**Subject: Amended MHI's Responses to US-APWR DCD RAI No. 379-2756 Rev 0**

Amended Response to Request for Additional Information  
No. 379-2756 Revision 0

**US-APWR Design Certification  
Mitsubishi Heavy Industries, Ltd.  
Docket No. 52-021**

**RAI NO.:** NO. 379-2756 REVISION 0  
**SRP SECTION:** 06.01.01 – ENGINEERED SAFETY FEATURES MATERIALS  
**APPLICATION SECTION:** 6.1.1  
**DATE OF RAI ISSUE:** 5/29/2009

Figure 1 SCC resistance of stainless steel against dissolved oxygen

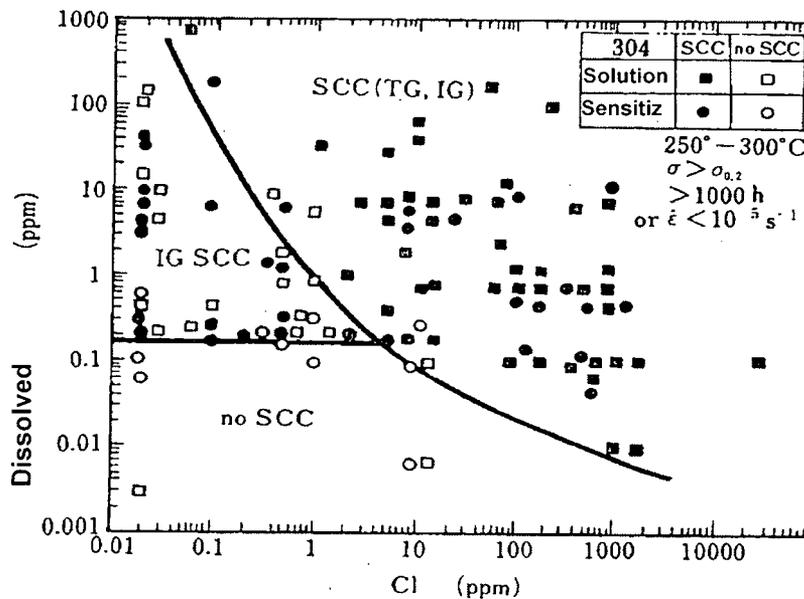
Table 6.1-1 indicates that non-low carbon austenitic stainless steels will be used to fabricate some ESF components. Given that the use of stainless steels, in LWRs, with a maximum carbon content of 0.03% has been shown to be highly resistant to stress corrosion cracking, the staff requests that the applicant modify FSAR Section 6.1.1 and Table 6.1-1 to limit the carbon content of austenitic stainless steel to 0.03% maximum or provide a technical basis for why this is not necessary.

Figure 1 shows the SCC potential of stainless steel as a function of dissolved oxygen and chlorides (Reference: 1st U.S. - Japan Joint Symposium on Light Water Reactors, Fuji, Japan (1978), presented by M. O. Speidel). This figure shows that SCC does not occur in the zone where dissolved oxygen and chlorides are low, even if the SS is sensitized. The US-APWR reactor coolant chemistry is well within the no-SCC area below the curve. This means that the standard grades of SS will not experience IGSCC in the US-APWR environment.
